UNITED STATES PATENT AND TRADEMARK OFFICE

APPLICATION NO.	FILING DATE	FIRST NAMED INVENTOR	ATTORNEY DOCKET NO.	CONFIRMATION NO.
10/629,298	07/29/2003	Sheldon Joseph Grywacheski	16448-US	6459
30689	7590	12/01/2005	EXAMINER KOVACS, ARPAD F	
DEERE & COMPANY ONE JOHN DEERE PLACE MOLINE, IL 61265			ART UNIT 3671	PAPER NUMBER

Office Action Summary	Application No.		Applicant(s)	
	10/629,298		GRYWACHESKI ET AL	
	Examiner		Art Unit	
	Árpád Fábíán Kovács		3671

DETAILED ACTION

FIG. 2

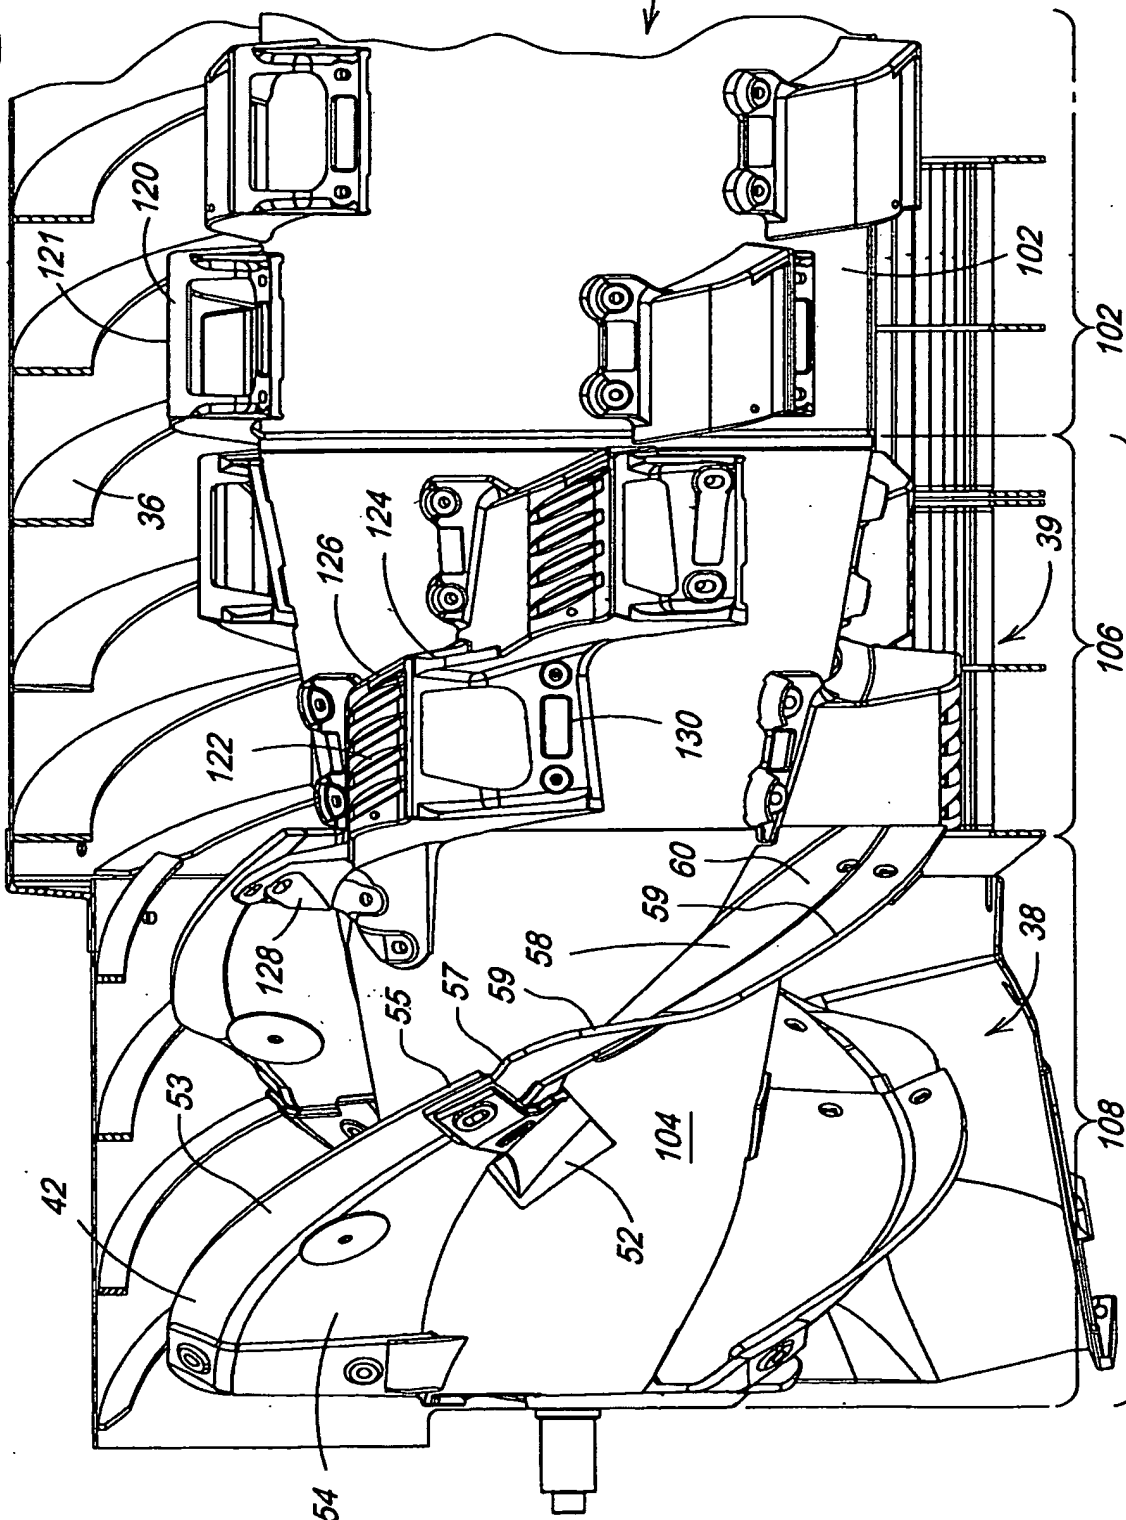
Final necessitated by Amendment & IDS (10/17/05); check ID see fig the threshing element and the infeed are connected in any one of them.

since it is clear from cl. 9, ln 13-18, that a threshing section "having at least one threshing element located on the aft-region," thus, the first mention of "threshing element" (line 12) does not refer to the same threshing element as the "at least one" Therefore, for example, in 4148323 patent, the infeed attachment element 61 extending from an adjacent threshing element at a rear thereof (i.e. the rear portion of 46).

a drum having a rearward cylindrical portion (45) and a forwardly extending frusto-conical portion (53) comprising an aft-region & a fore-region (see fig 2);

on the fore-region is/are located: an infeed section having a infeed element (46) as claimed;

on the aft-region is/are located: a threshing section having a threshing element (63) as claimed;

the infeed element is bolted by a mounting assembly (59, 61; col. 4, ln 11-14);

infeed element is a helical infeed flight (see fig 2);

a second threshing element (48) on the cylindrical portion.
